Action Point	Response
6	Confirmation that Northumberland County Council (NCC) are satisfied with text in Art 7(b)(ix).	From a highways perspective, we are satisfied with the text as set out in Art 7(b)(ix)
7	NCC to respond to the Applicant's response to ExQ1 DCO.1.39 and DCO.1.40, in relation to Art 11.	The applicant's response to ExQ1 DCO.1.39 confirms that the revised DCO has consistency in notifying the Street Authority at 6 weeks and, as such, have no comments to make. (Noting DCO.1.40 is linked more to Article 12 so comments have been made on this under Point 8)
8	Applicant and NCC to consider Art 12 and identify any matters of disagreement.	Following on from our meeting with the applicant on 15th February, the applicant's consultant has shared notes of the meeting on 10th March, which have provided clarity in relation to Article 12, along with the points of clarity made in the Hearing Sessions. It is understood that these notes will form subsequent iterations of the Statements of Common Ground to which we will comment and confirm.

Response to Point 36

Figure 36.1 Extract from TADU ATC Traffic Speeds Dashboard (Source: TADU 2018)

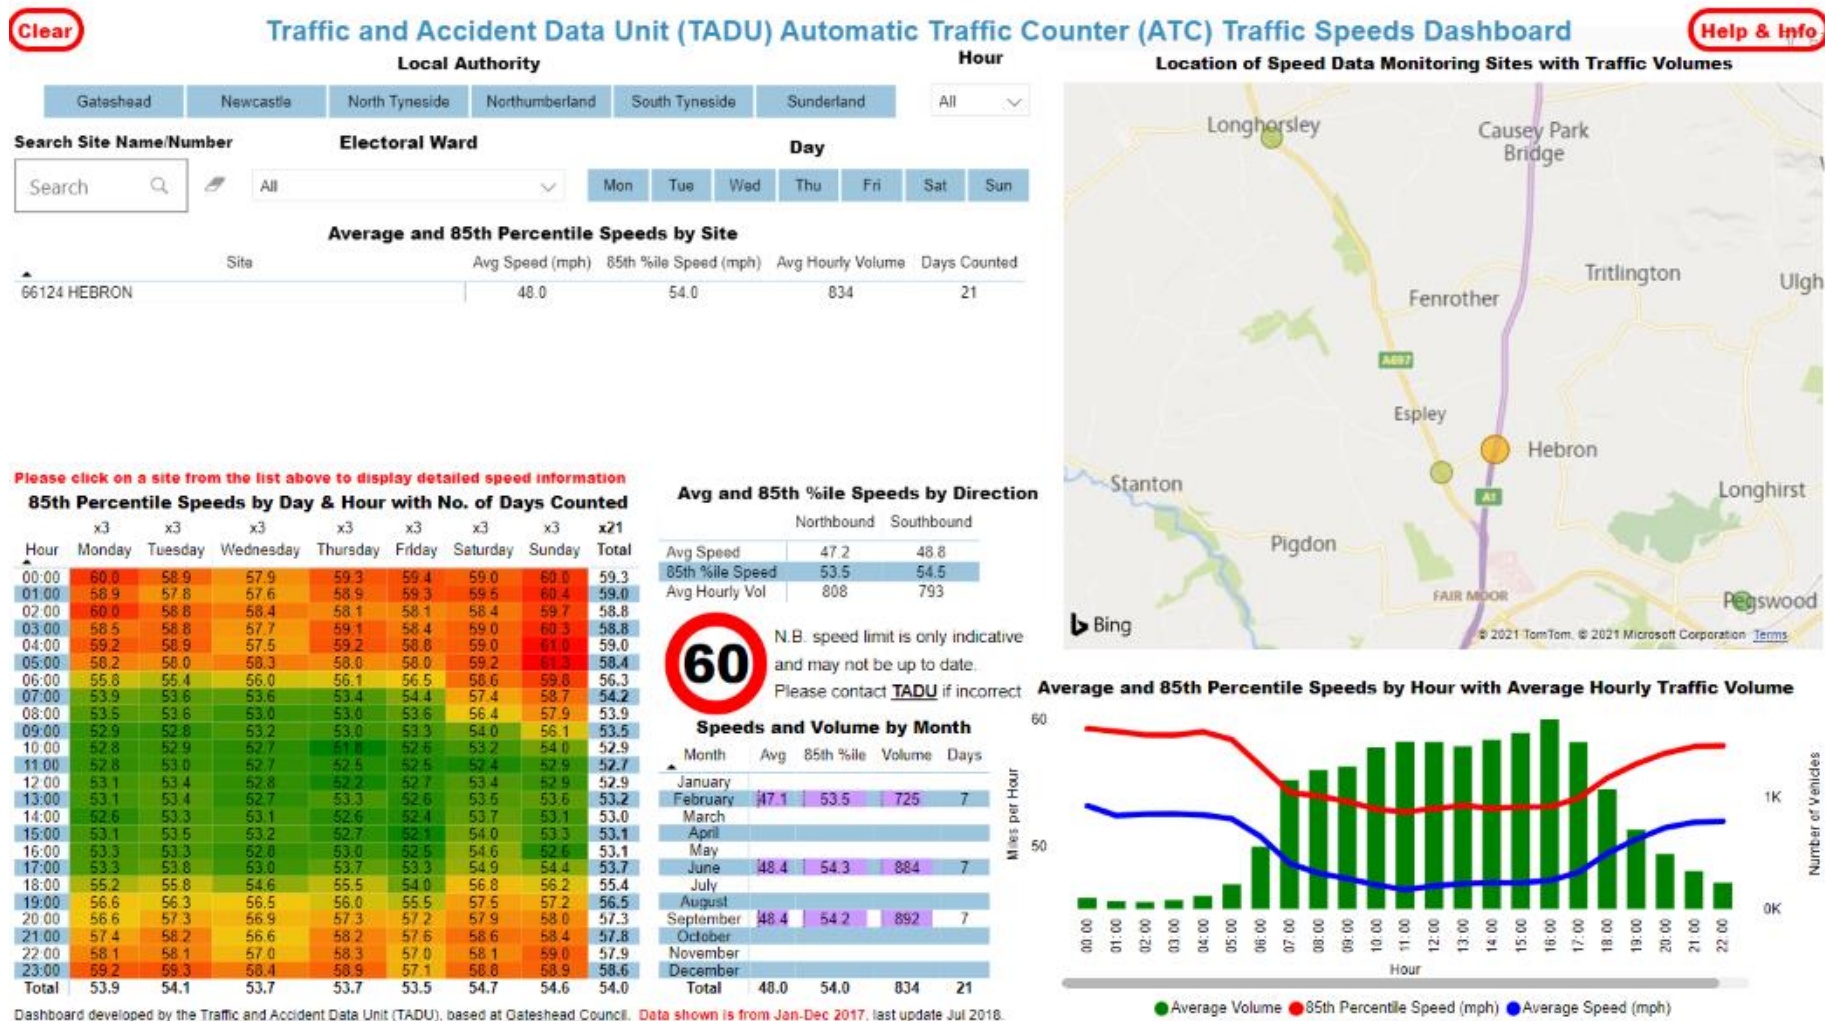
Analysis of these flows indicate an 83% reduction on the 2020 figures and 87% reduction on the 2019 figures on the busiest section (Fenrother to Earsdon). The reduction in traffic flows will lead to an increase in traffic speeds. Figure 36.1 below shows the 2017 traffic speeds at Hebron on the A1. Although showing hourly figures for volume of traffic, the graph (bottom right) shows how speed increases as traffic flows drop.

Based on this we would predict at least a 5mph increase in the 85th percentile speed on the de-trunked section as a result of the reduction in traffic flows.
